# **Technical information**

## Product information BMW brake pads 8DB 355 012-321 / 8DB 355 015-601

### Changed brake pads

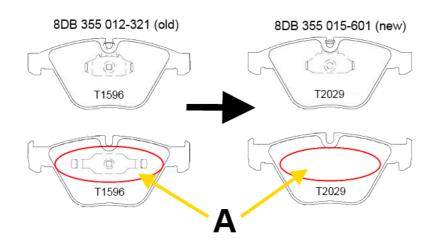
Brake pad 8DB 355 012-321 / T1596 will be replaced by brake pad 8DB 355 015-601 / T2029.

The difference between both brake pads is the missing retaining spring (A) on the brake pad 8DB 355 015-601 / T2029 on the fist side. The missing retaining spring does not have any influence on the comfort conduct of the brake pad.
